Test results of Validation test 1b and Cycle modifications

Prepared by Japan

the 12th DHC group
under GRPE/WLTP informal group

29 March 2012

1.2. Test result of Passenger car

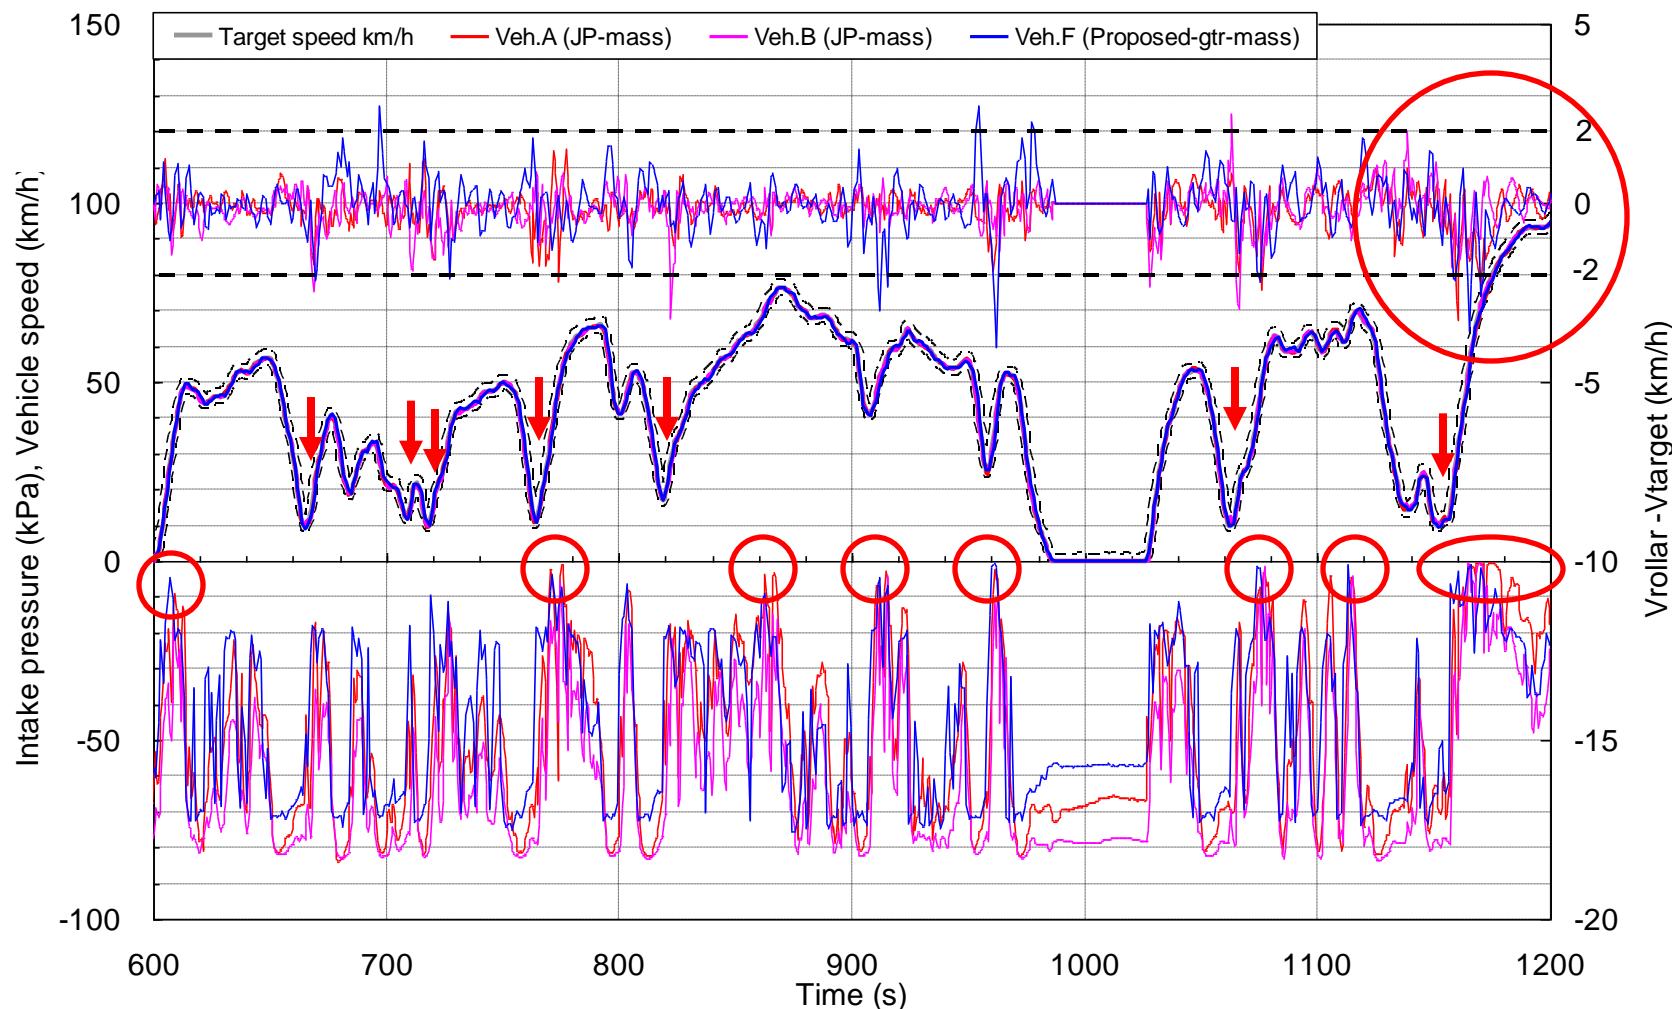
ARROW (↓): Require precise acceleration pedal/clutch operation

CIRCLE (○): Hard to follow the trace (require close to W.O.T. operation)

1.2. Test result of Passenger car

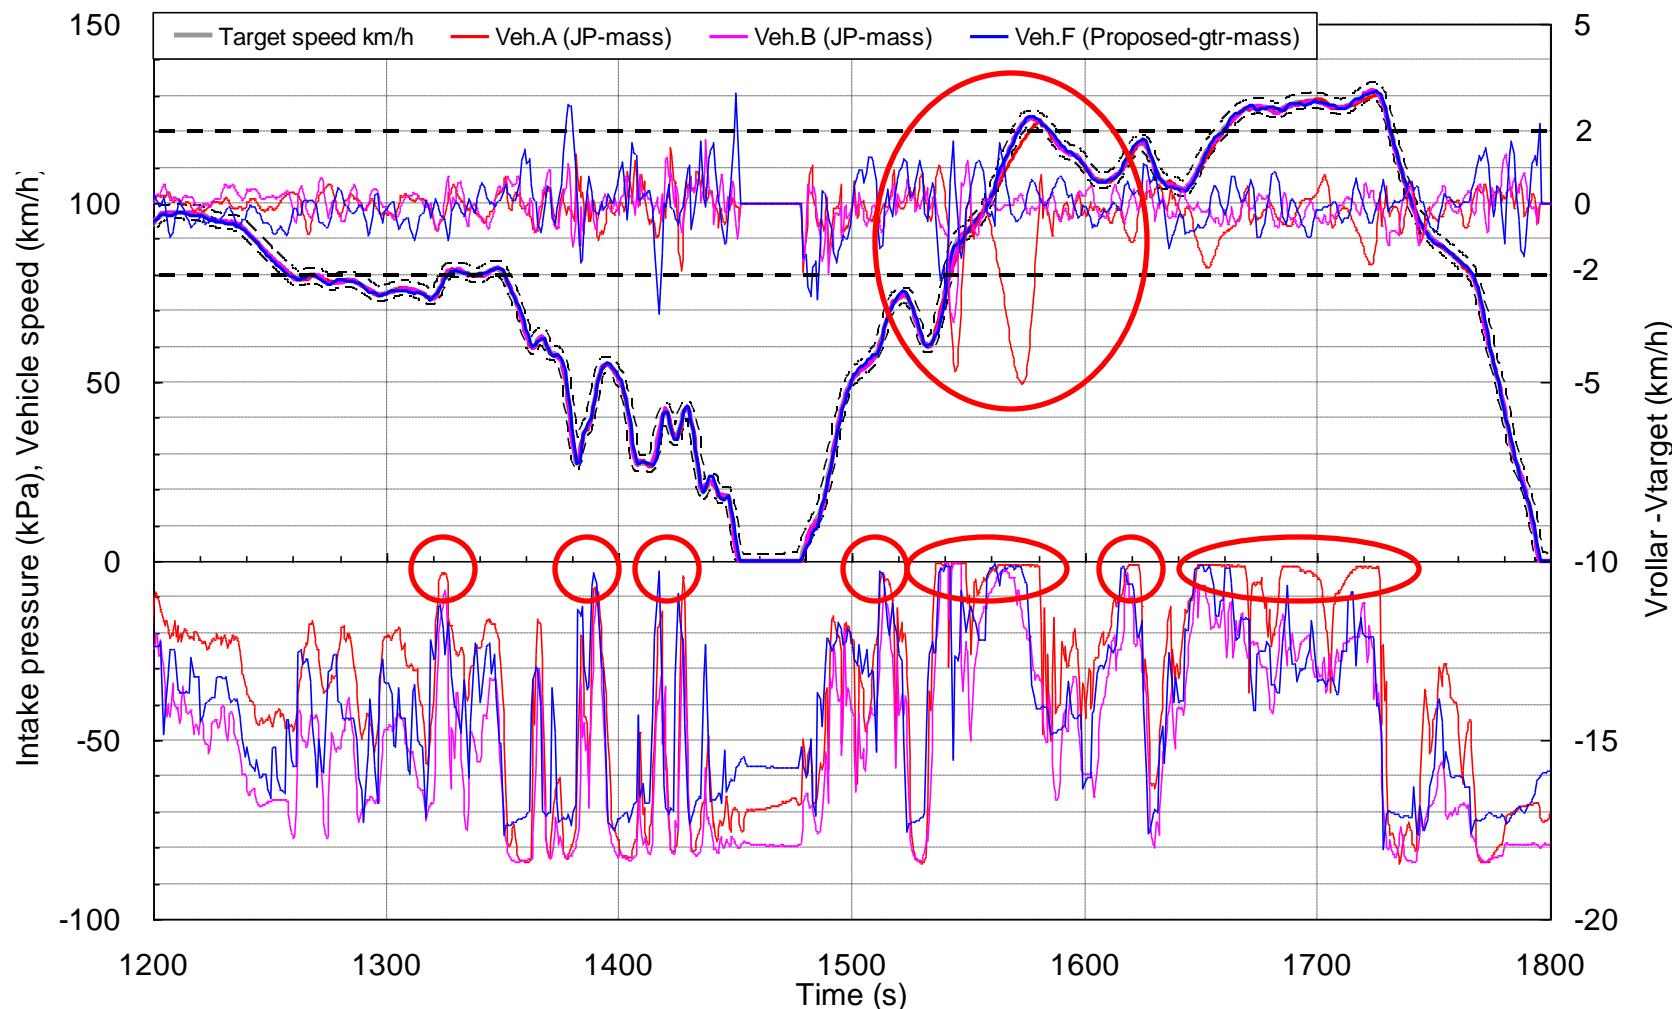
ARROW (↓): Require precise acceleration pedal/clutch operation

CIRCLE (O): Hard to follow the trace (require close to W.O.T. operation)

1.2. Test result of Passenger car

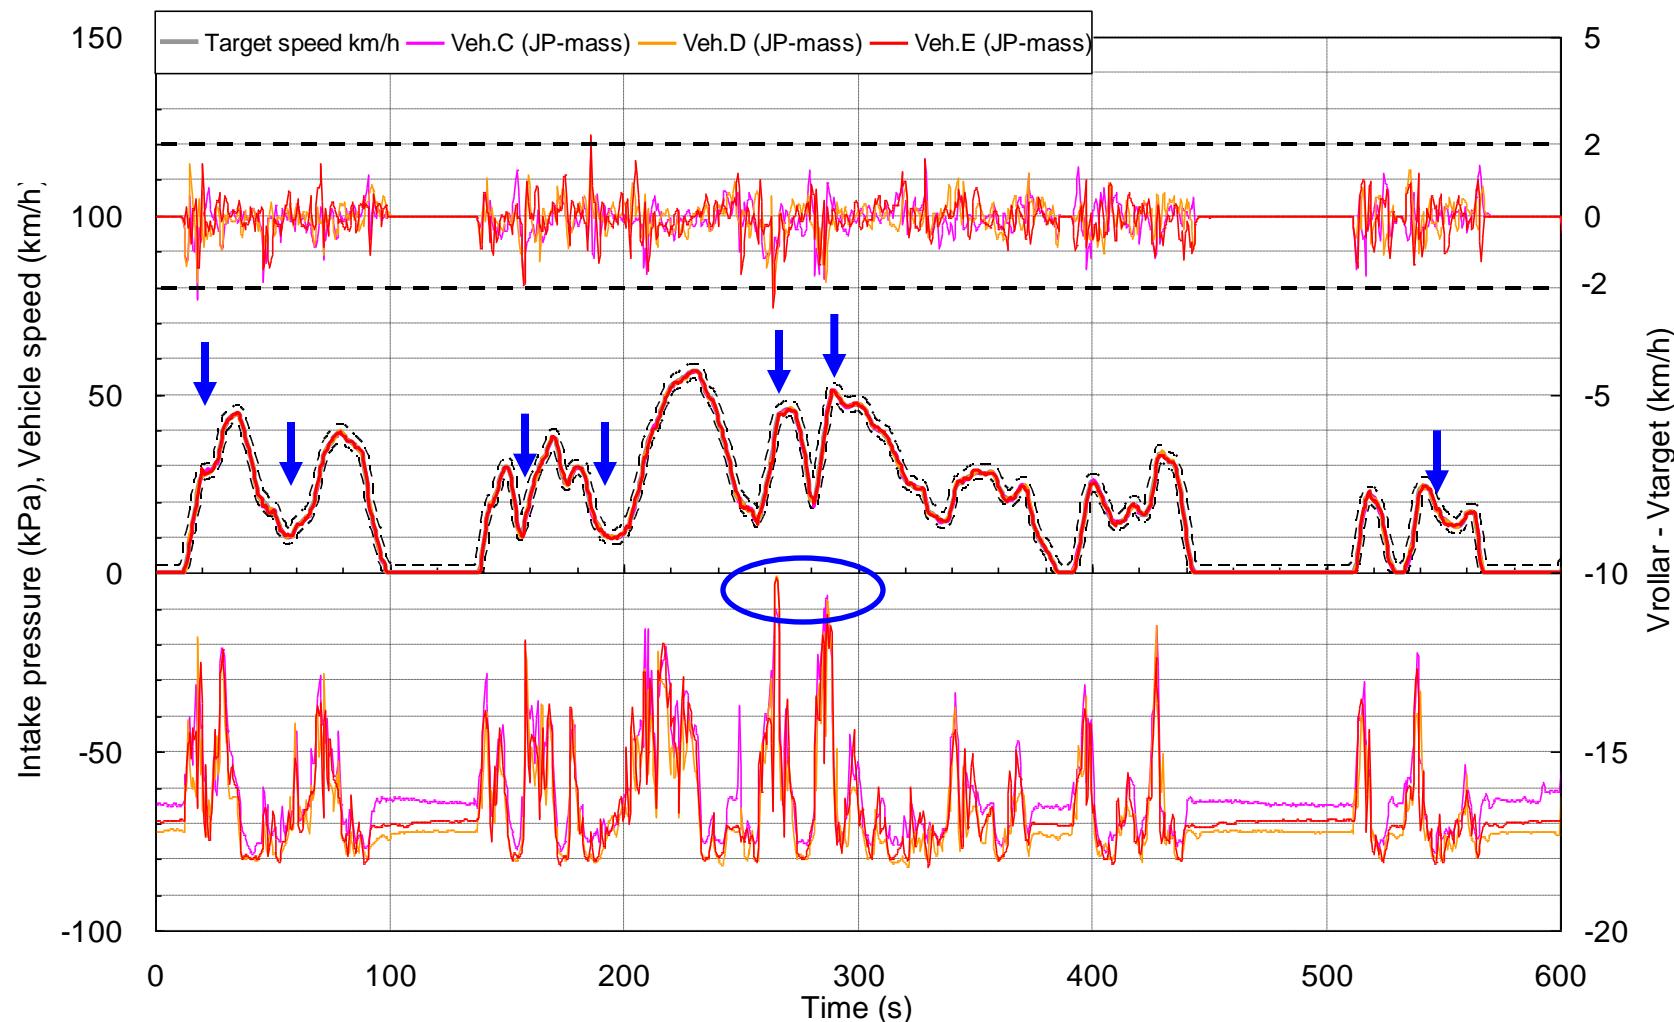
ARROW (↓): Require precise acceleration pedal/clutch operation

CIRCLE (O): Hard to follow the trace (require close to W.O.T. operation)

1.3. Test result of Light duty commercial vehicle

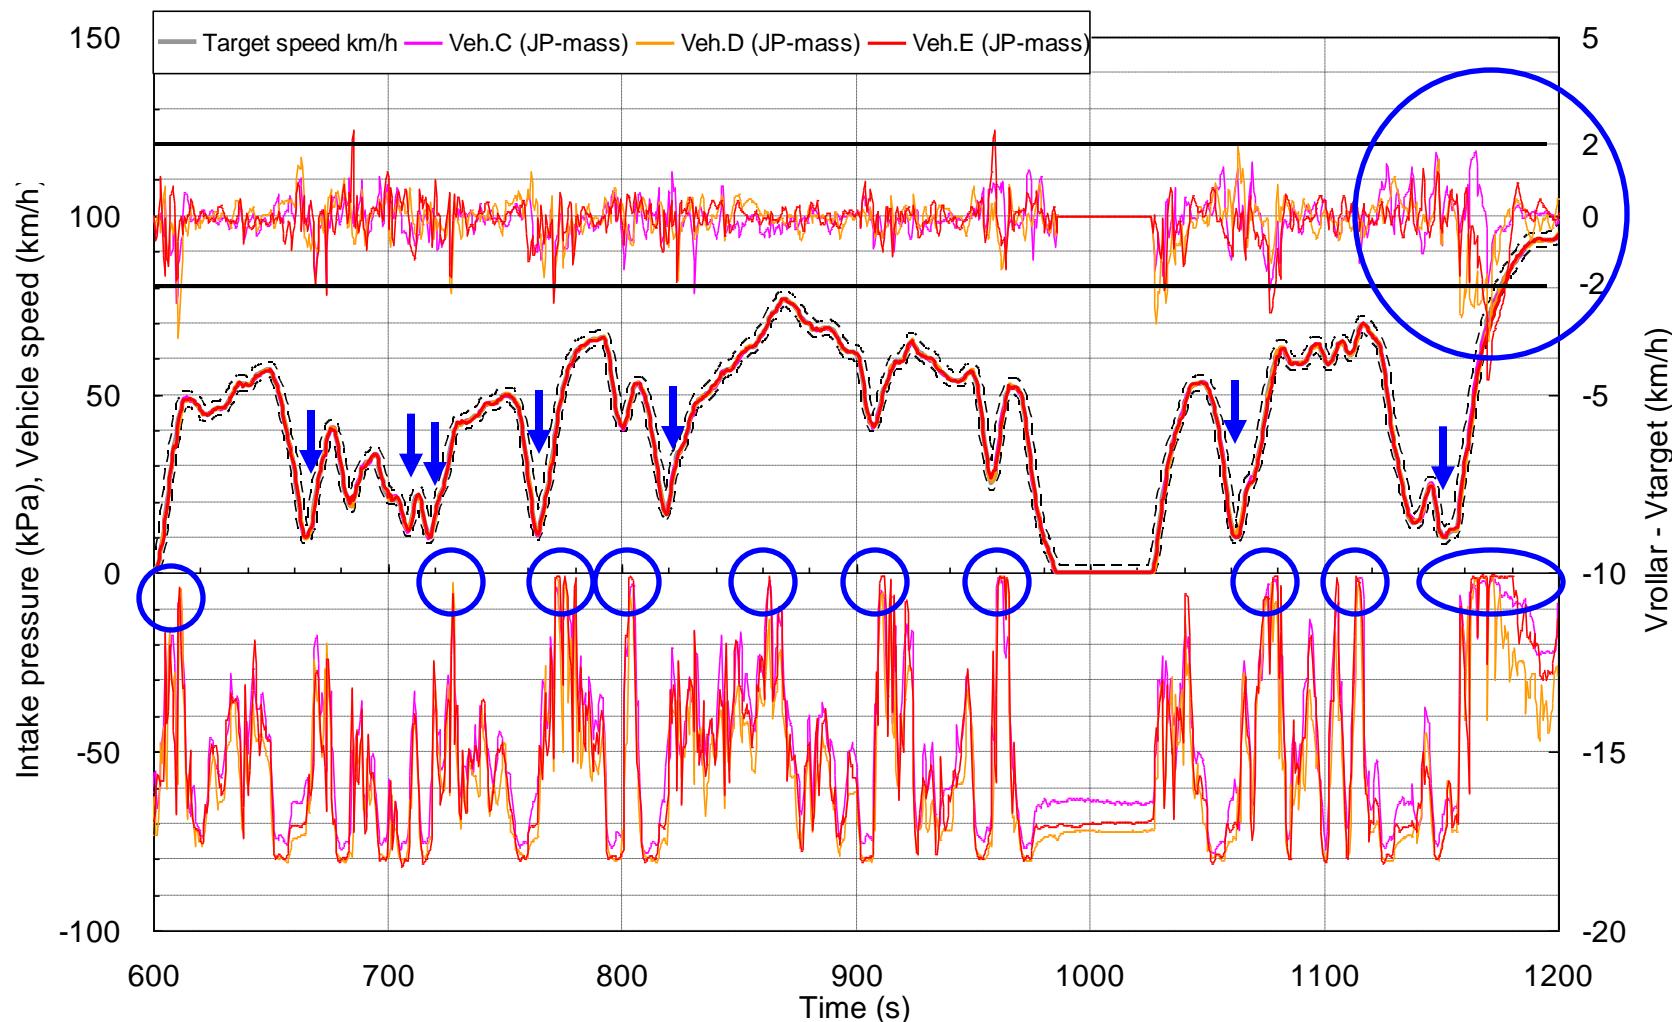
ARROW (↓): Require precise acceleration pedal/clutch operation

CIRCLE (○): Hard to follow the trace (require close to W.O.T. operation)

1.3. Test result of Light duty commercial vehicle

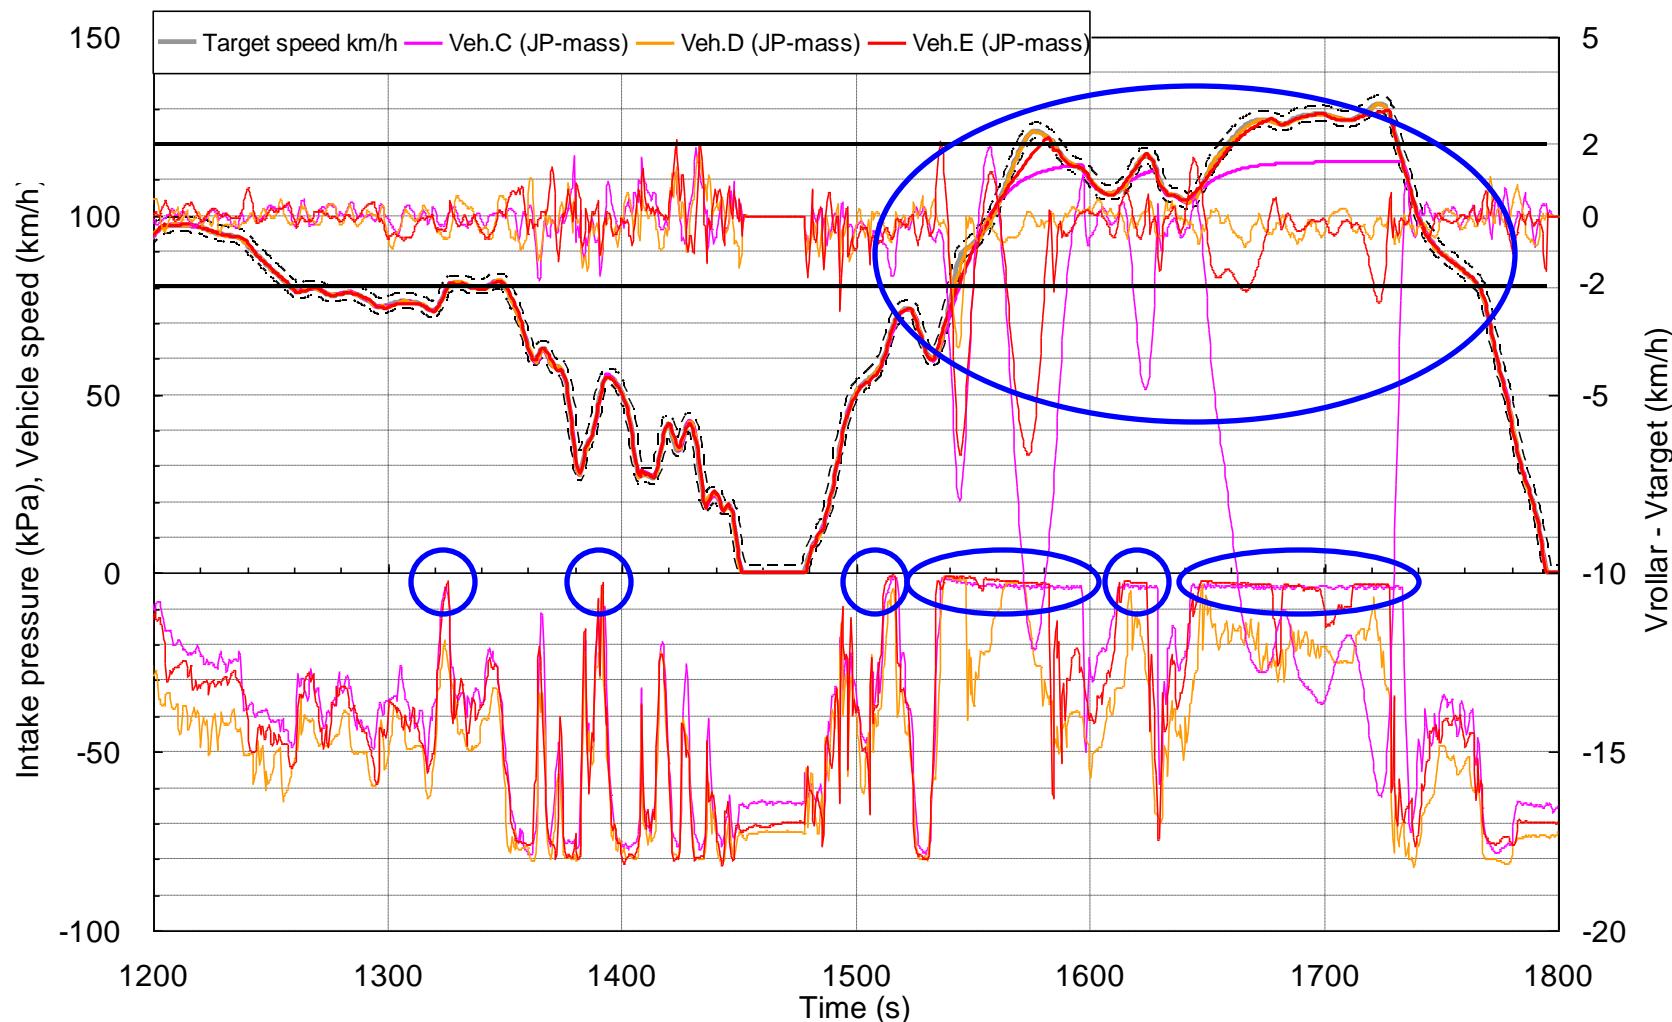
ARROW (↓): Require precise acceleration pedal/clutch operation

CIRCLE (O): Hard to follow the trace (require close to W.O.T. operation)

1.3. Test result of Light duty commercial vehicle

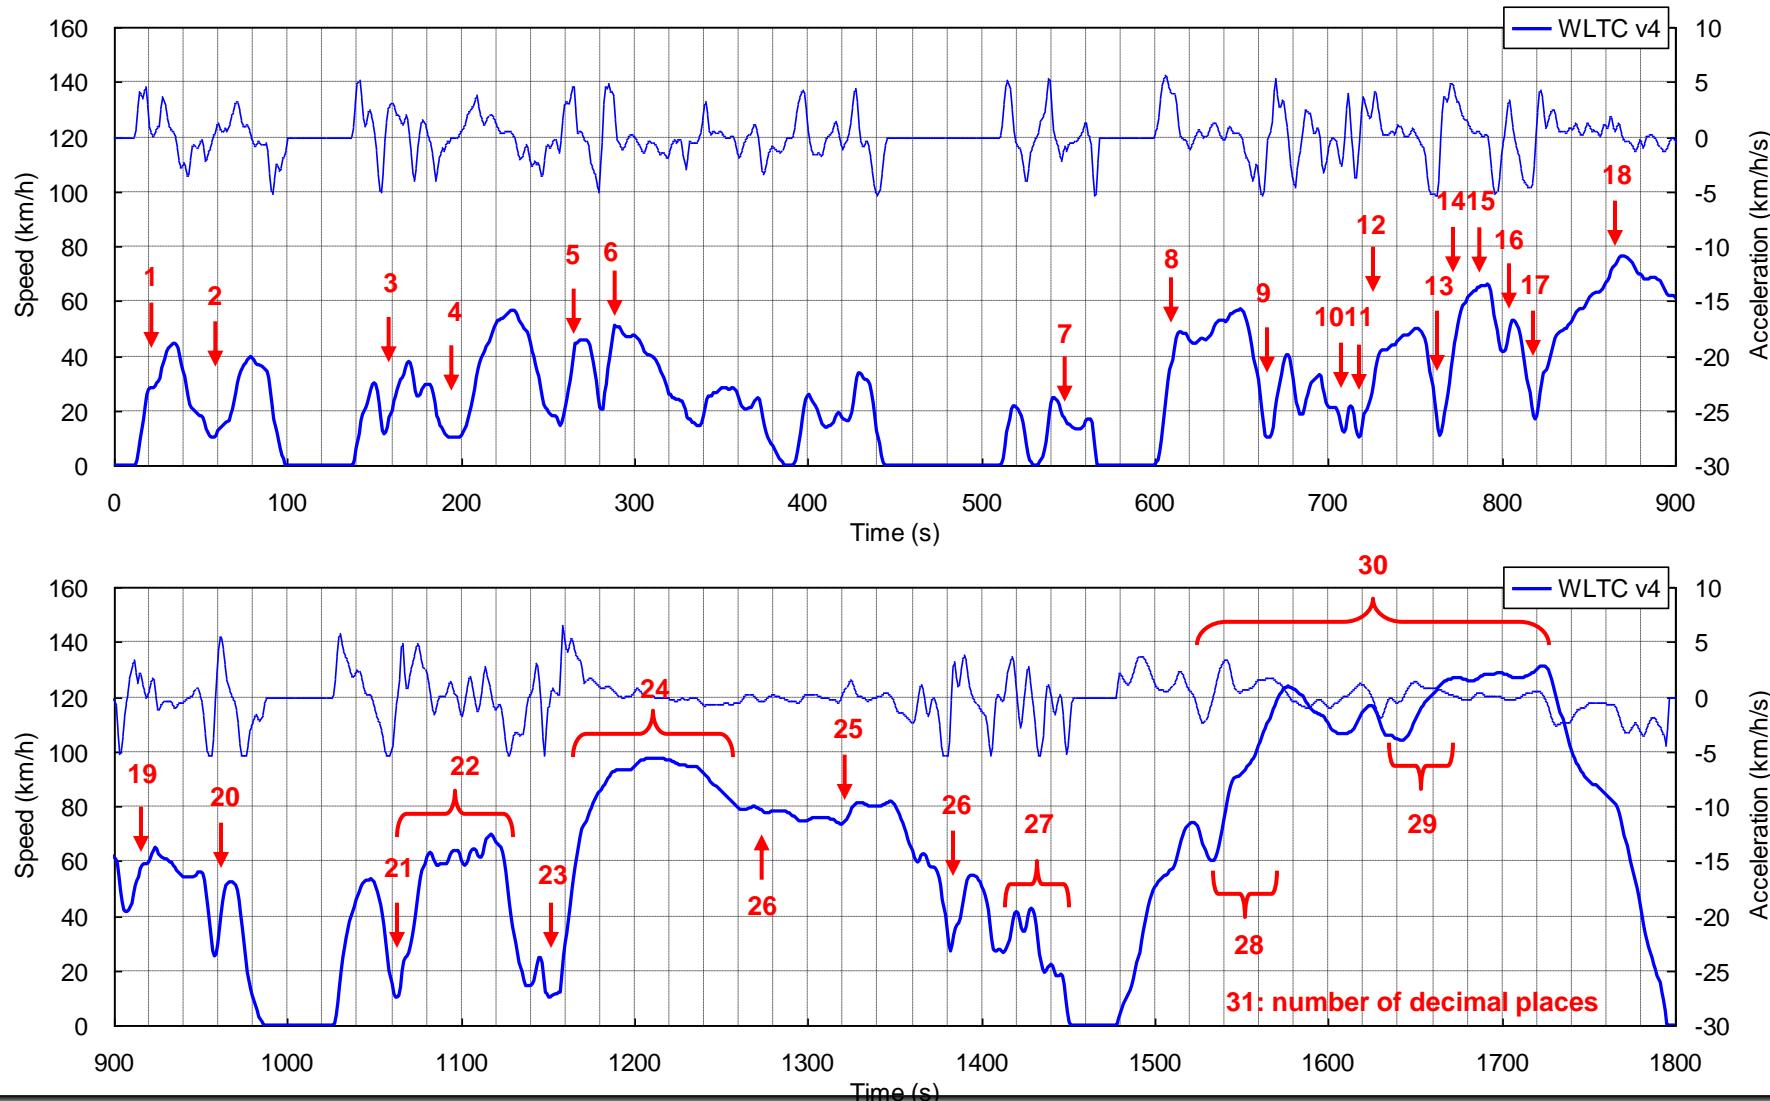
ARROW (↓): Require precise acceleration pedal/clutch operation

CIRCLE (O): Hard to follow the trace (require close to W.O.T. operation)
